## SERVICE BULLETIN

Ref: SRV-021-001

Product: AirFlex, SDX and RDX

Re: Center Draper Drive Chain Tension

Figure 1

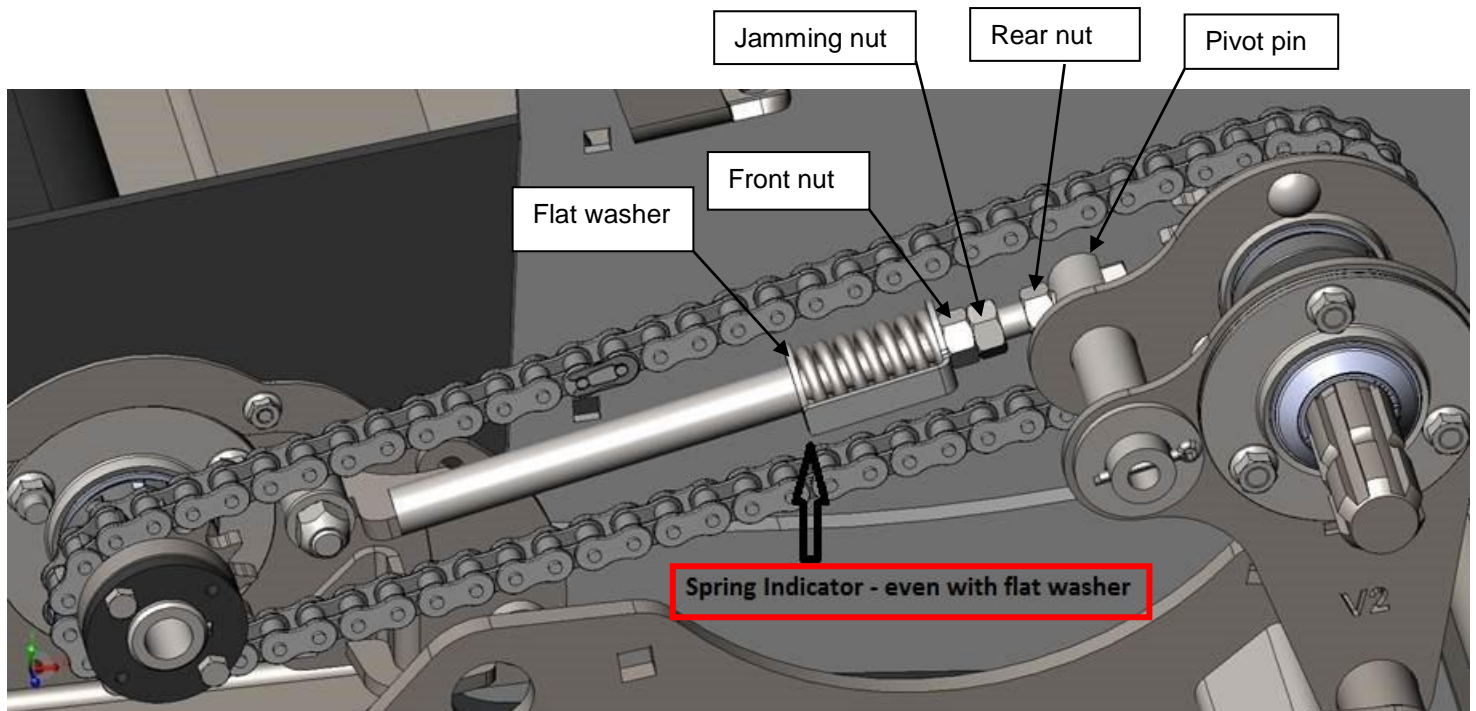
**Problem:** The Center Deck drive chain does not stay at the correct tension. If the nuts are not in the correct position the spring tension can change.

**Solution:** If possible, use the combine to lift the header off the ground, and retract the tilt cylinder all the way. Ensure the rear nut of the tension rod is tight against the pivot pin, keeping the tension rod (bolt) in position. The tension on the drive chain is correct when the spring indicator is even with the flat washer. The adjustment is obtained by tightening the front nut. Once the proper tension is achieved the second nut should be jammed against the front nut holding the spring position. See call outs in Figure 1.

Figure 2

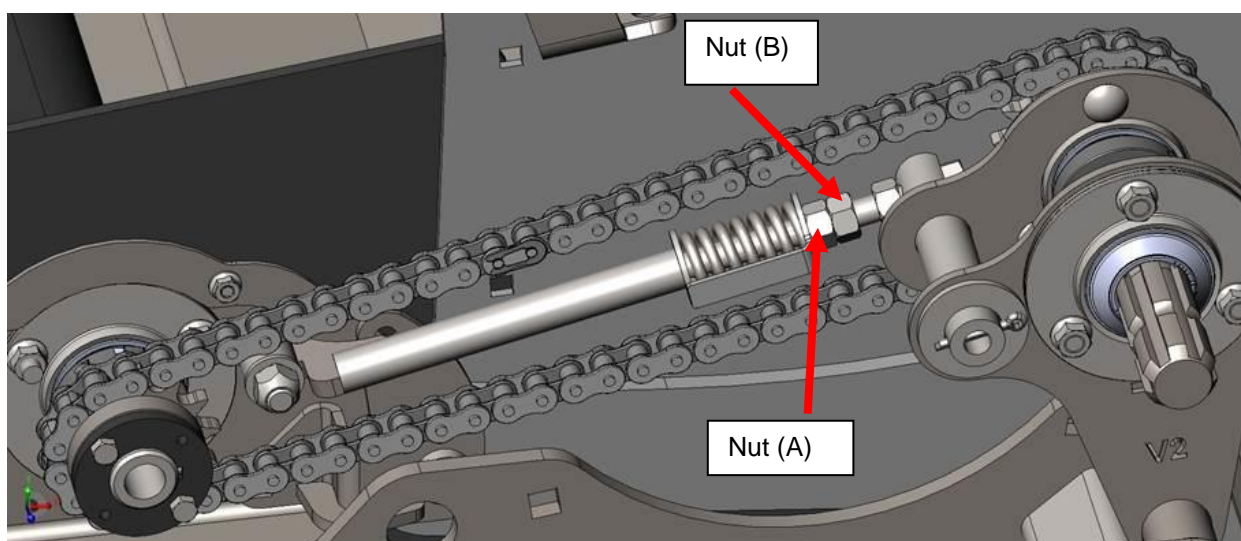
Re-check the center draper drive chain tension when the header is lifted off the ground by the combine and when the tilt cylinder is retracted as this may change the geometry of the center draper drive system.

- Tighten nut (A), closest to the tension indicator, until the tip of the indicator is in alignment with the washer on the other end of the spring. This will compress the spring and adjust the chain to the proper tension.
- While holding nut (A) jam the second nut (B) against the nut (A). This will secure the compressed spring and tension indicator from moving. Figure 2
